TOLEDO - LUCAS COUNTY PLAN COMMISSIONS

REF: SUP-4004-22

SUBJECT: Special Use Permit for Community Recreation-Active at 1111 E. Manhattan Blvd

LANDSCAPE PLAN

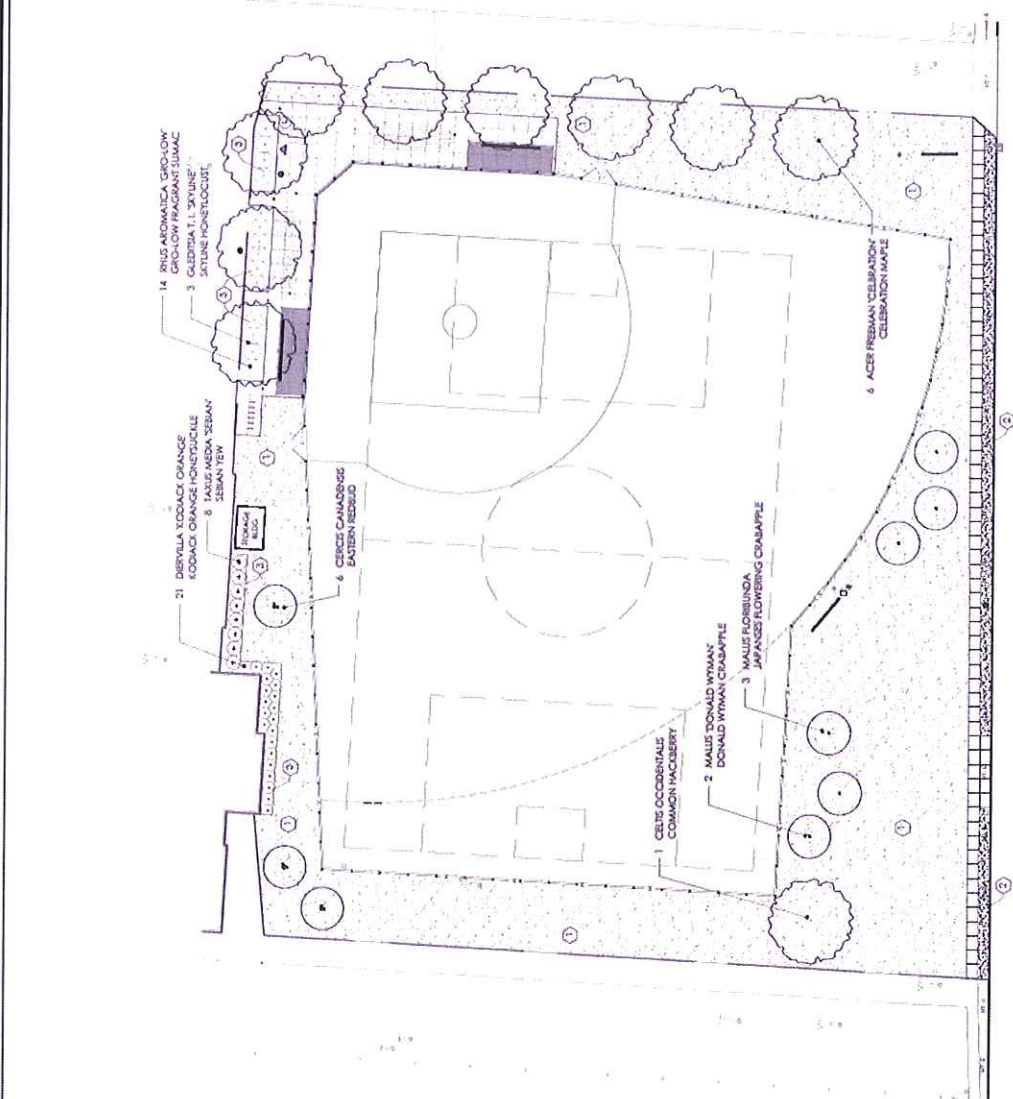
Bicycle parking is required pursuant to Off-Street Parking Schedule "A" (TMC§1107.0300). A minimum of one (1) bicycle space shall be provided per ten (10) automobile parking spaces. The existing parking lot at 1111 E. Manhattan Blvd. has eighty (80) total parking spaces, requiring at least eight (8) bicycle parking spaces. The landscape plan depicts twelve (12) bicycle parking spaces and is acceptable as depicted.

Per **TMC§1108.0202** – *Frontage Greenbelts*, sites are required to provide a minimum fifteen-foot (15') wide frontage greenbelt and contain at least one (1) tree for every thirty feet (30') of frontage. Trees are not required to be evenly spaced and may be clustered. The submitted landscape plan depicts seven (7) trees and one (1) existing tree along the front of the property. With 367' of frontage, the site requires twelve (12) trees in total. Four (4) additional trees along Manhattan Blvd are required as a condition of approval.

The site is Zoned Residential and abuts Industrial Zoning to the north and east, requiring a Type A Landscape buffer. However, the portion of the site being developed is 250' away from the Industrial District to the north, and a driveway runs along the eastern edge of the property. The landscape plan shows six (6) new trees on the eastern border of the athletic field and one (1) existing tree to remain. Shrubs along the eastern border, lining the driveway shall be provided on a revised landscape plan. As the site will be for youth games, the shrubs are intended not only to buffer but help discourage children from crossing into the driveway. A revised landscape plan depicting the shrub row shall be provided and approved by the Director.

As there is no expansion of the parking lot proposed, parking lot landscaping is not required. However, a perimeter landscape buffer shall be provided where the parking lot abuts the athletic field. The landscape plan depicts three (3) trees abutting the parking lot with a shrub row and foundation plantings. The parking lot is ±175' in width, and perimeter landscaping requires one (1) tree every thirty linear feet (30') with a shrub row. However, pedestrian access between the athletic field and the parking lot is necessary for the use. The proposed perimeter landscaping is acceptable as depicted.

- a. A fifteen foot (15') greenbelt is required along Manhattan Blvd and shall include one (1) tree per every thirty feet (30') of frontage. Trees are not required to be evenly spaced and may be clustered. **Not acceptable as depicted. Four (4) additional trees along Manhattan Blvd shall be depicted on a revised landscape plan.**

- b. A Type A landscape buffer is required where Residential abuts Industrial. This buffer requires four (4) trees and twenty (20) shrubs per 100 linear feet. **Not acceptable as depicted. A shrub row shall be depicted along the eastern edge of the site, west side of the existing driveway. Subject to the Director's approval,**

- c. Perimeter landscaping must be installed along any parking lot area adjacent to a street, place, or driveway, or which is visible from an immediately adjacent property, and must be at least ten feet (10') in width. A minimum of at least one (1) canopy tree must be provided for each thirty linear feet (30'), plus a continuous shrub row with a minimum height eighteen inches (18"), **acceptable as depicted,**
